**From:** Hilary Saunders  
**Sent:** 03 March 2016 16:38  
**To:** Planning  
**Subject:** Fwd: NYM/2015/0891/FL Coach Rd Pahase 2 10892-31 nymnp drg 03\_03\_16  
**Attachments:** D10892-05B.pdf

Please see attached a copy of amended drawing D10892-05B. This now shows sectional elevations to the North and South running from the Main road A169 to the rear (West) boundary.

PROJECT: Coach Road Sleighs Phase 2

Drawing: PROPOSED House Types Elevations

DRAWING No: D10892-05 REV: B

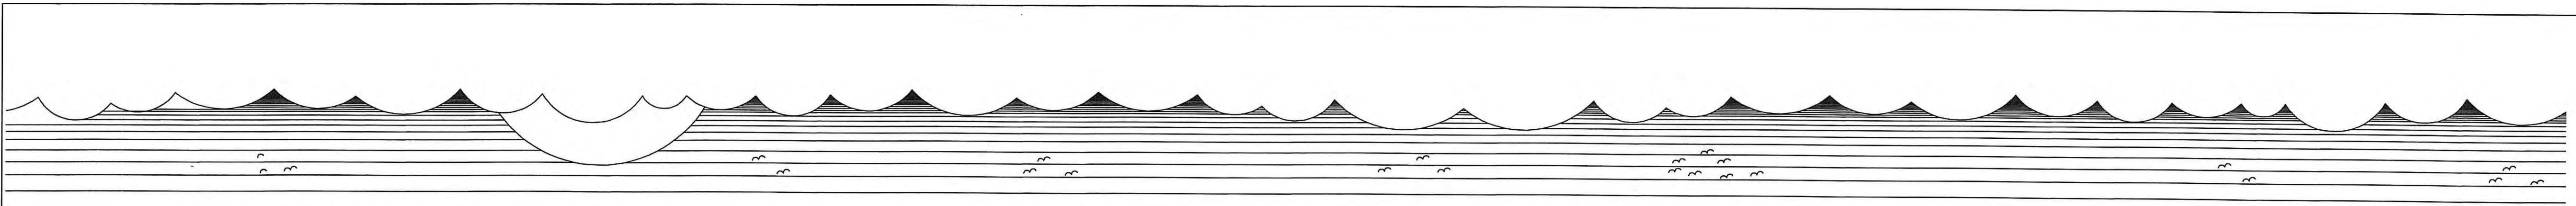
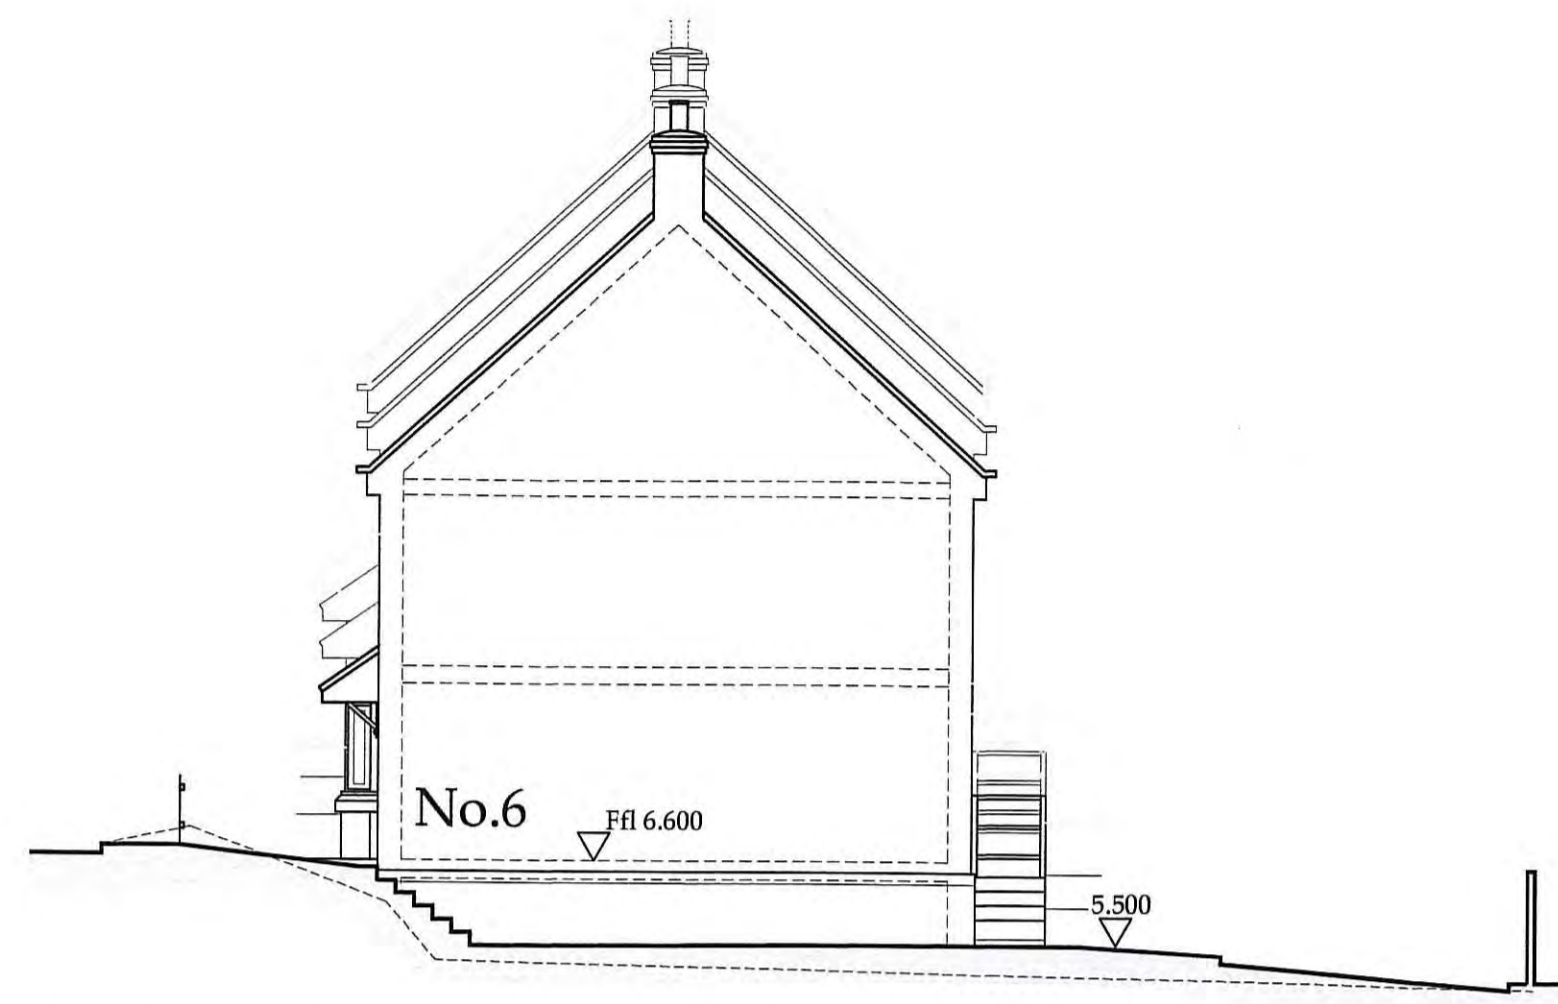
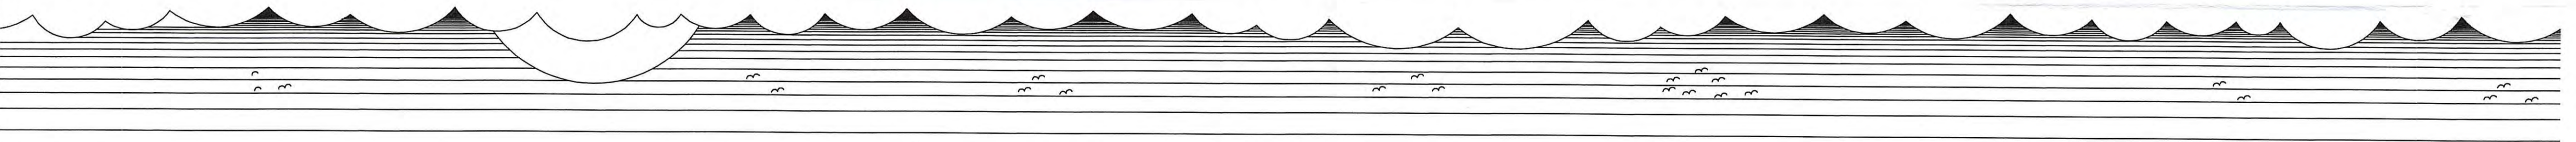
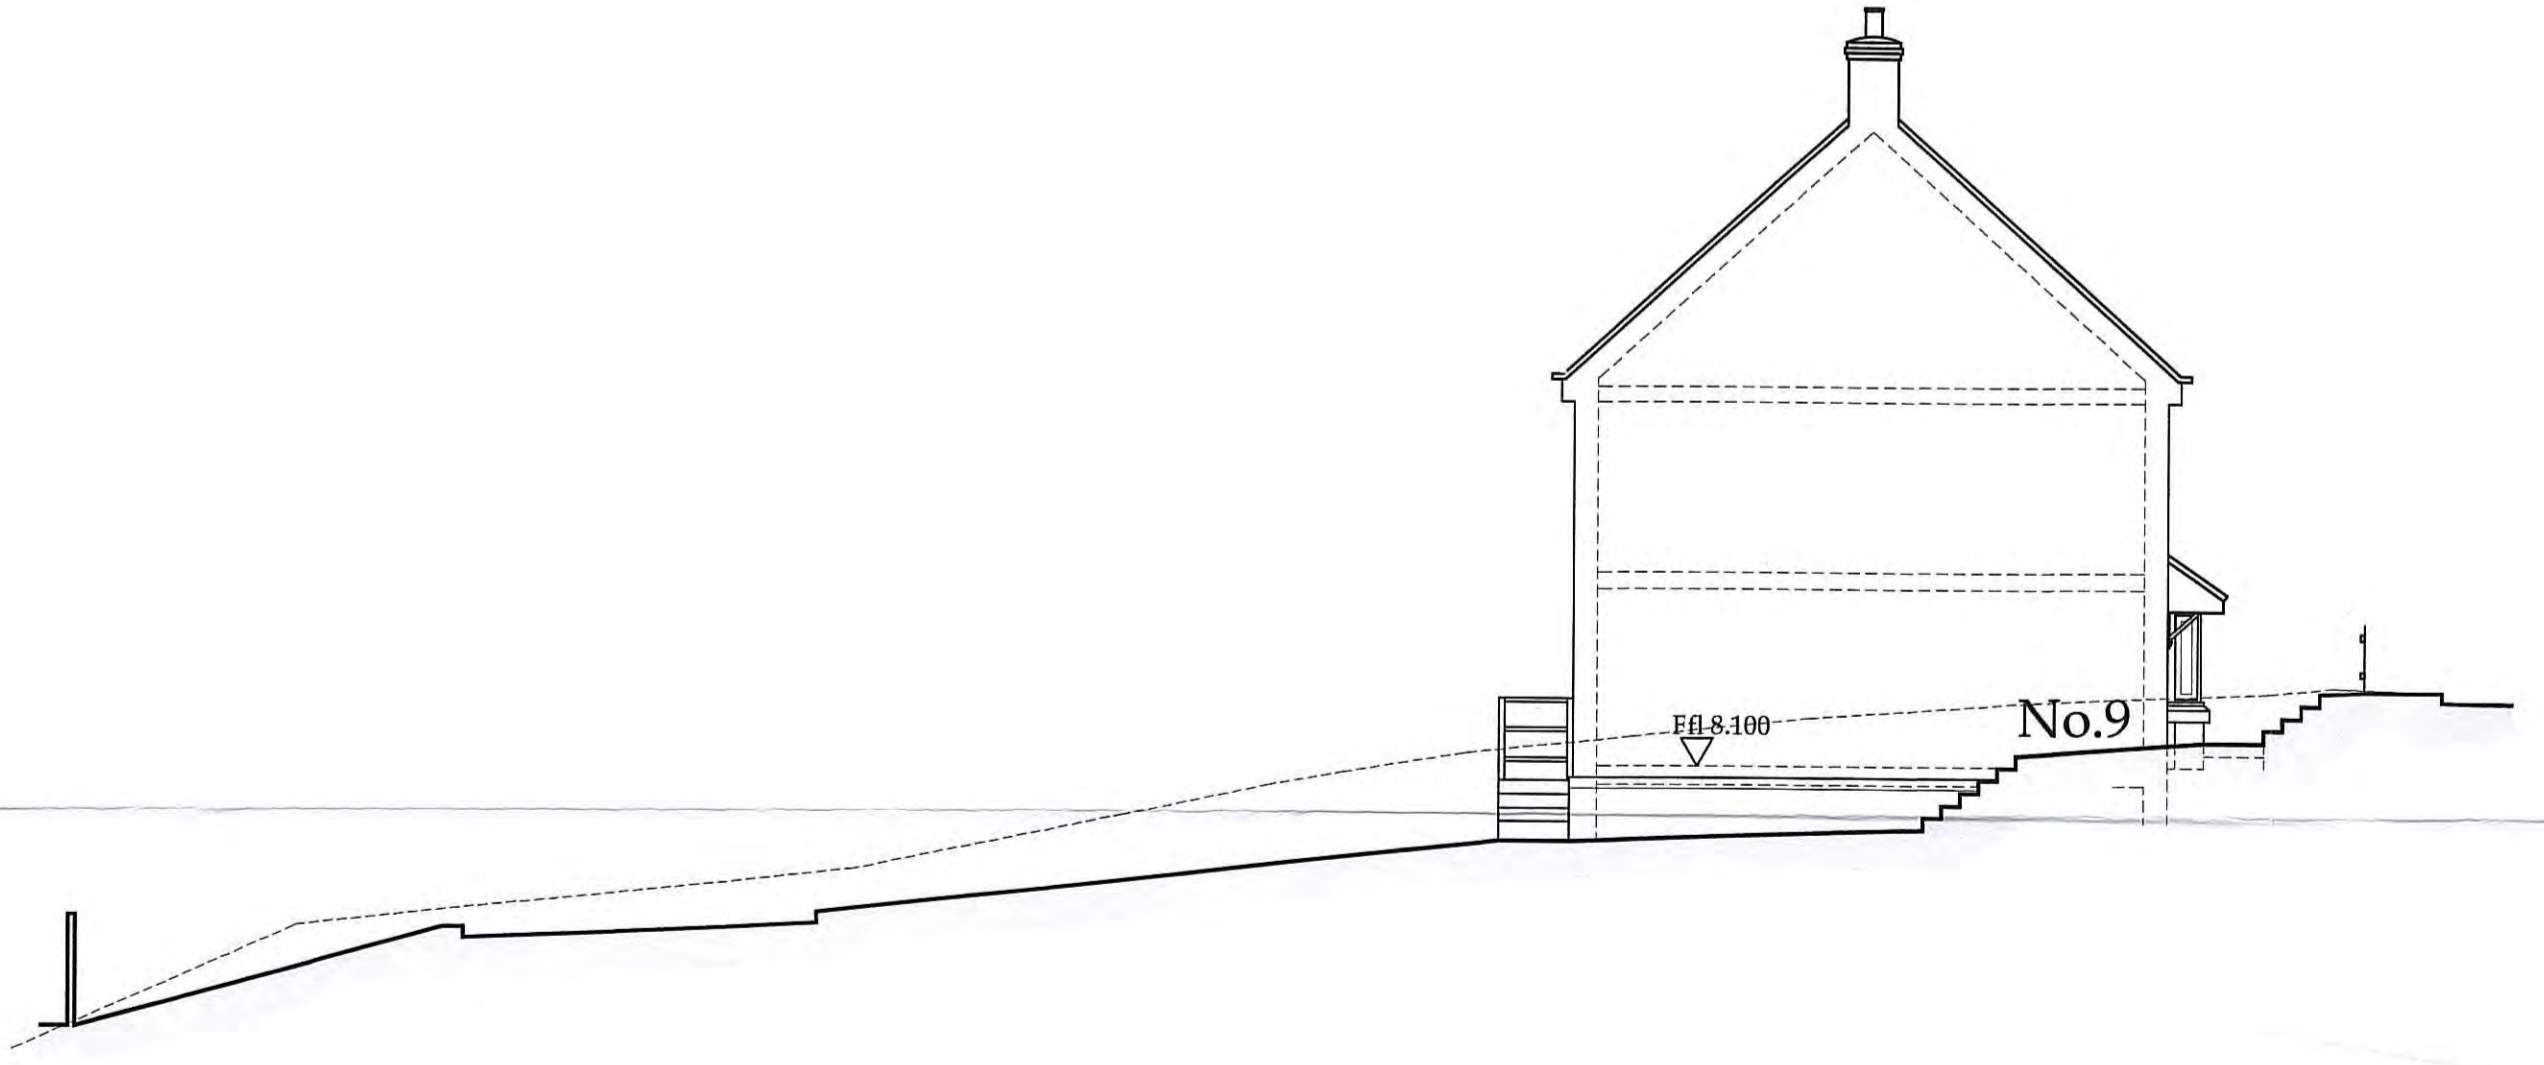
We have shown existing (dashed line) and proposed ground levels which show that the revised scheme more closely follows existing topography. Also a slight horizontal band of brickwork at ground floor level has been introduced to provide horizontal emphasis.

B	03/03/16	CE	Elevations updated
A	01/12/15	NID	Provisional for comment
REV	DATE	BY	AMENDMENT
